Ref: 10780.010
3 September 2018

**Southern Cross Hospital Expansion, Newtown
Transport Response to Section 92 Request for Further Information**

Southern Cross Hospital Ltd (“Southern Cross”) lodged an application for resource consent (SR 414740) to expand their current operation at 90 Hanson Street, Newtown. Wellington City Council has subsequently issued a Section 92 request for further information, of which a number of items relate to traffic and transport matters. A response to each of these is provided in turn below.

On-street parking occupancy

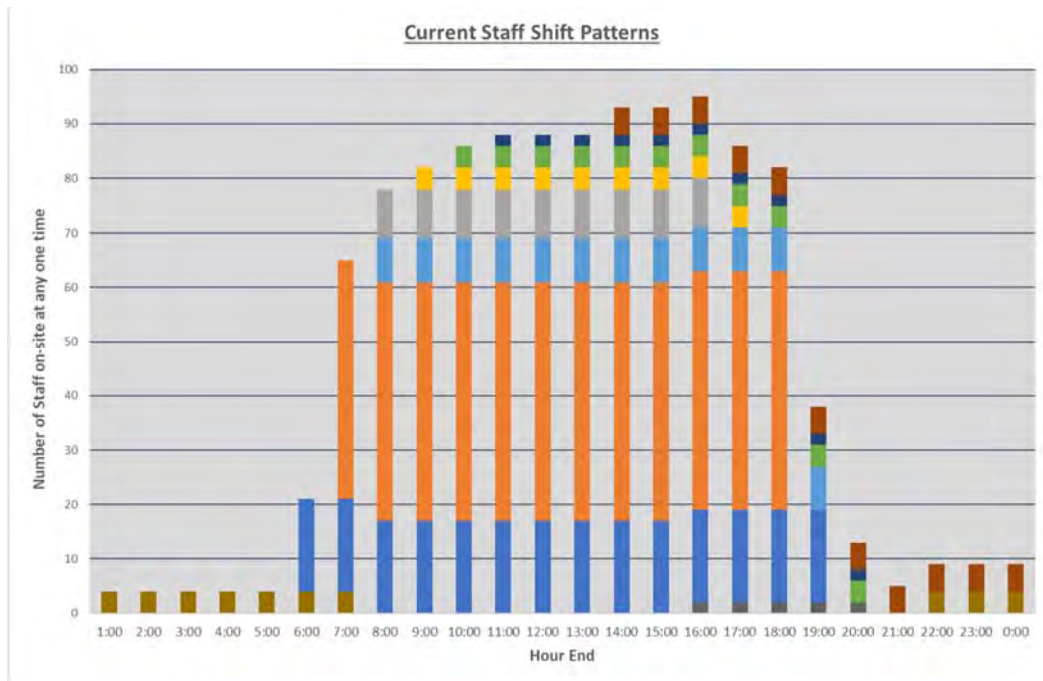
Clarify the details of the on-street parking surveys and clarify the usage for the different types of parking restrictions.

The observed on-street parking occupancy data has been interrogated further to separately identify occupancy within the Residents² and Unrestricted (‘All day’) spaces, as illustrated below.

The occupancy levels recorded within the allocated resident’s carpark indicate there is significant availability throughout the course of the day, ensuring a good level of amenity is maintained for these users.

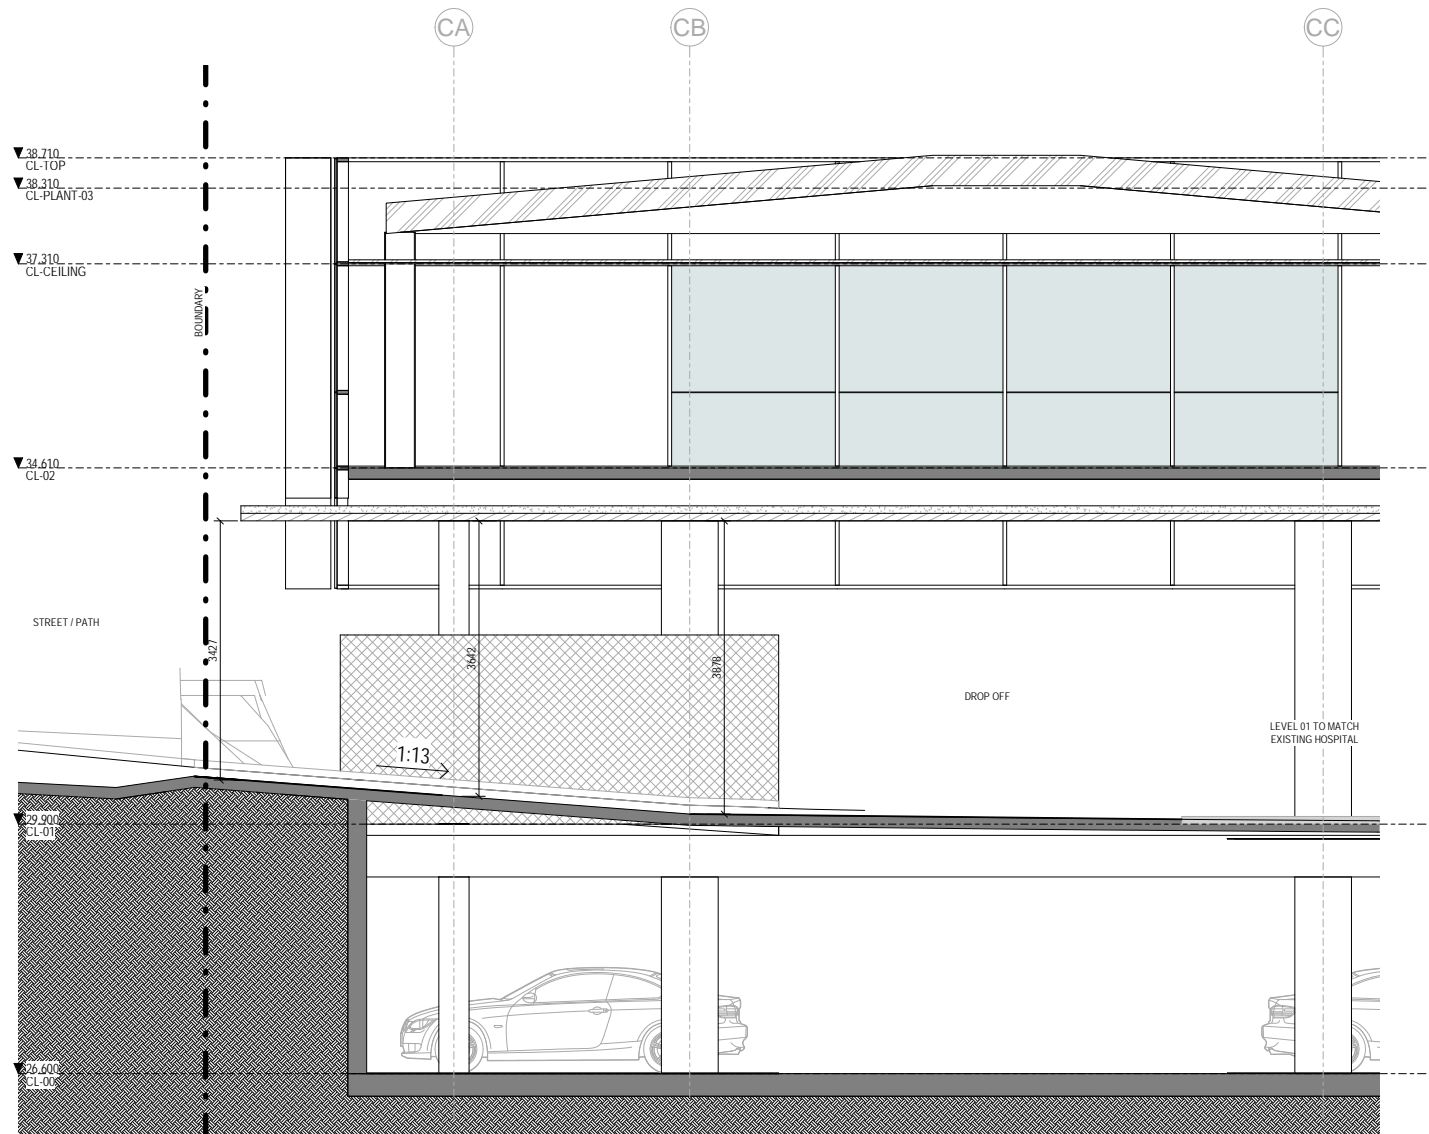
The applicant has stated that the hospital currently leases 35 parking spaces at the nearby sports ground for the staff. The Applicant should clarify the address of this sports ground.

The spaces currently leased by the hospital are located within the southeast corner of the adjacent property, at 54 Hall Street, as illustrated below.

1 CROSS SECTION ENTRY
A00.006 1:50

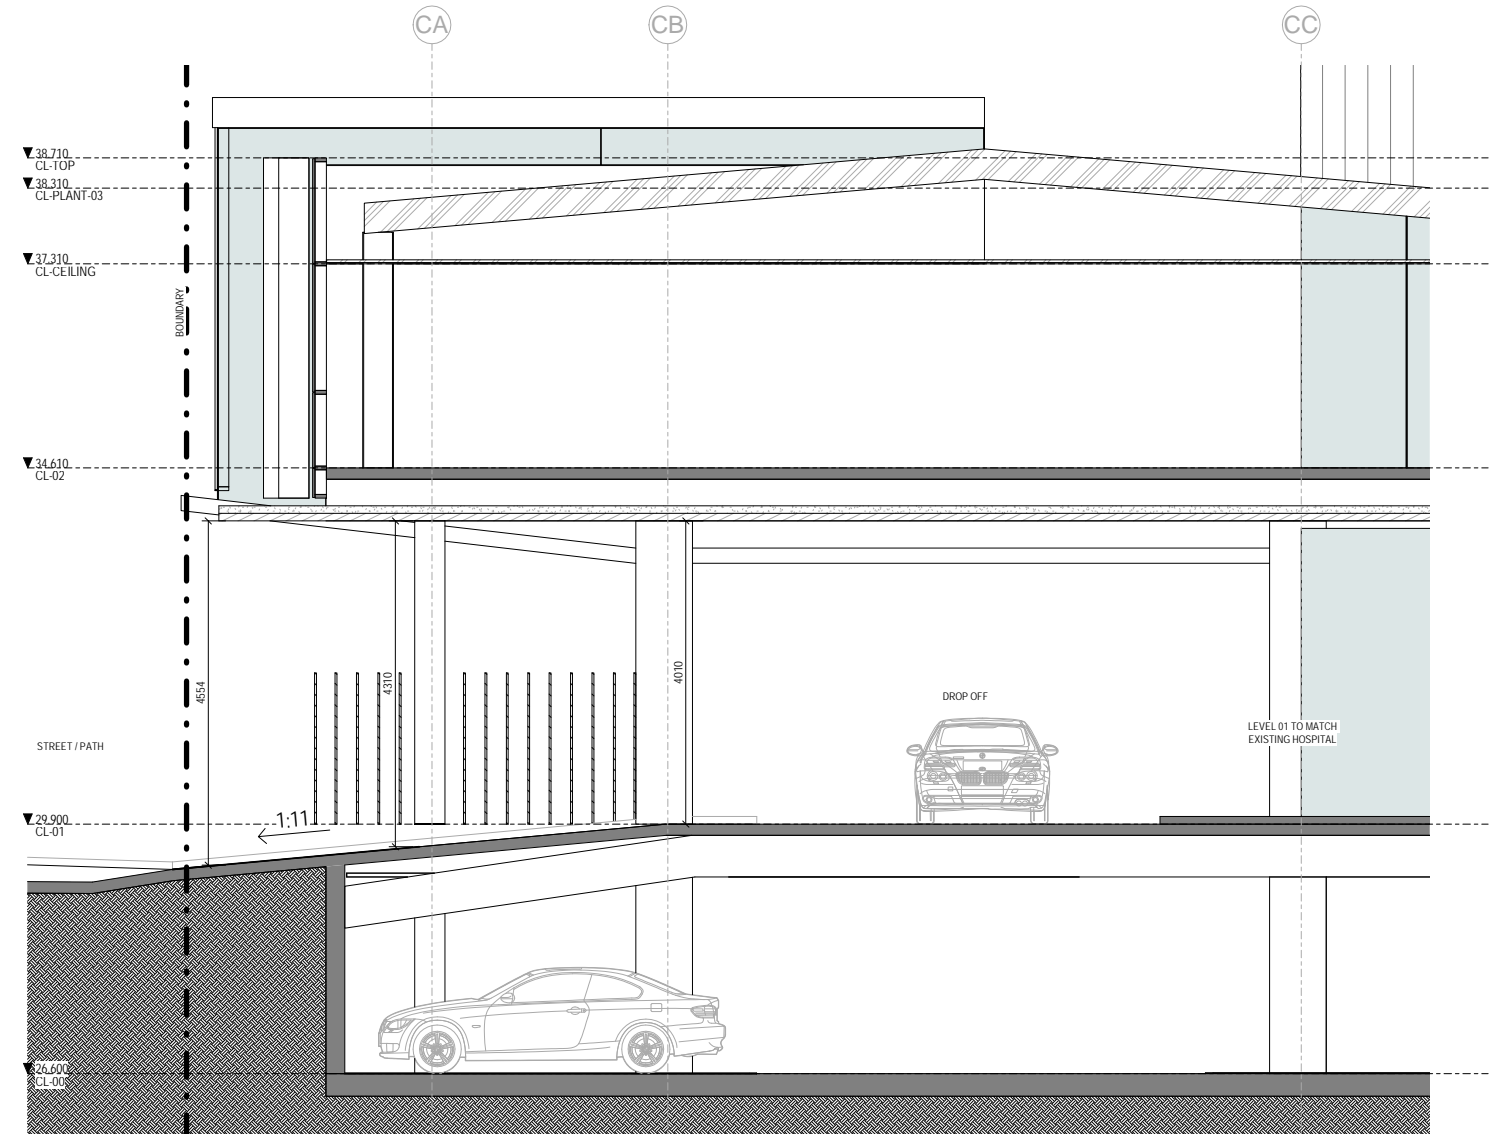
Confirm the driveway gradient to the level 1 parking lot. The driveway gradient must not exceed 1:20 for 6m back from the property boundary.

The developed driveways design has necessarily had to be cognisant of achieving a suitable level grade between the drop-off area and the floor level of the existing main entrance (i.e. to provide an accessible route between the drop-off and the existing hospital building level). The gradient of the driveway at the entrance to the lower parking level is illustrated within the detail of the plans provided at **Appendix A**. As shown, the gradient at the entry driveway can be confirmed at 1:13 (downgrade into the site) and on the exit driveway gradient at 1:11 (downgrade to the footpath).

These gradients deviate from the 1:20 measured from the property boundary for the first 6 metres into the site, as identified in AS/NZS2890.1. However, the Standard goes on to describe that grades of up to 1:8 are considered appropriate in instances where the driveway slope is a downgrade; where the user class is 1, 1A or 2; and where the access connects to a Local Road and serves a carpark of not more than 100 spaces. In essence, the issue of gradient here is to ensure that drivers exiting a site have adequate forward inter-visibility to pedestrians

on the footpath i.e., if the slope is an upgrade then driver sightlines may be limited if the vehicle bonnet is elevated above the line of the adjacent footpath, which is not the case in this instance given the downgrade. With the exception of user class the exit driveway design satisfies these caveats, and provides a shallower grade than the 1:8 specified.

Overall, the alignment through the drop-off area serves to limit vehicle operating speeds and the urban design elements included at the carpark exit appropriately delineate pedestrian routes and provide good forward inter-visibility to the adjacent Hanson Street footpath. The design as proposed is therefore not considered to introduce safety effects that are any different from achieving a 1:20 grade.

Southern Cross Hospital Expansion
Lower Level Parking Layout

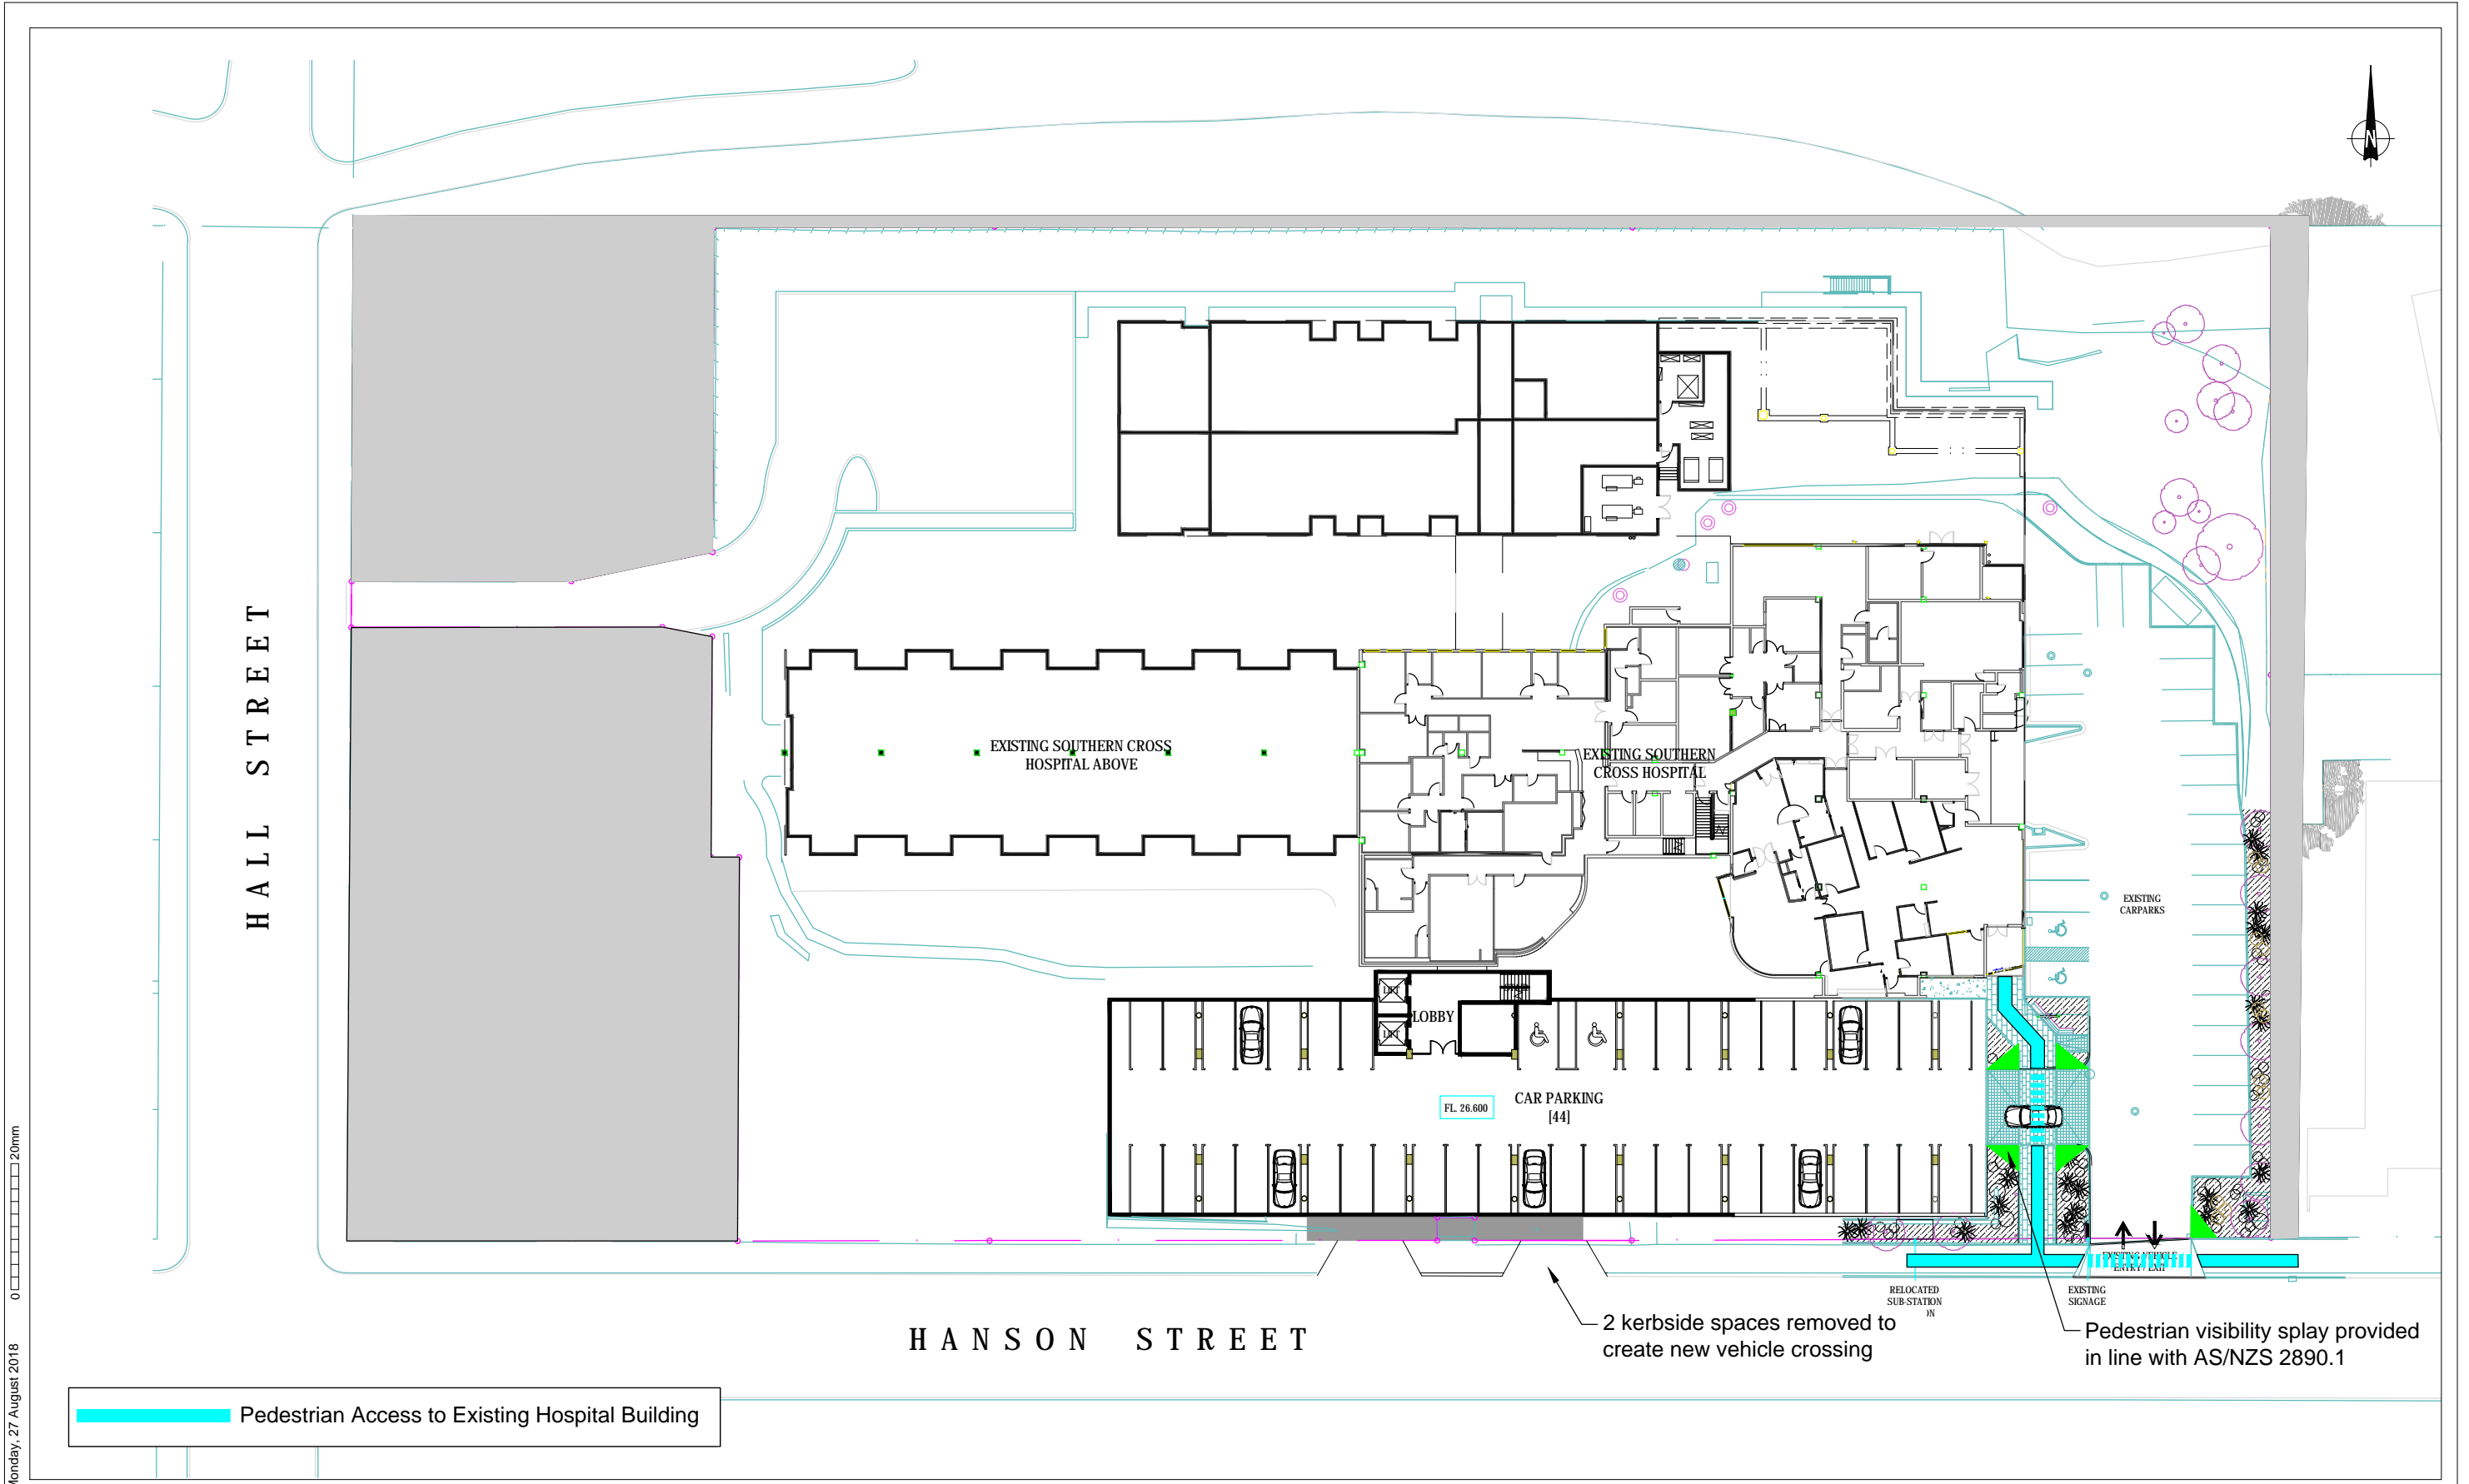
Show visibility splays at all the vehicle crossings and between the driveway and pedestrian paths within the site. The proposed internal pedestrian paths must be defined clearly with complying visibility splays.

The plans provided at **Appendix B** illustrate the pedestrian visibility splays around the site (as green triangles), which satisfy the requirement of AS/NZS 2890.1.
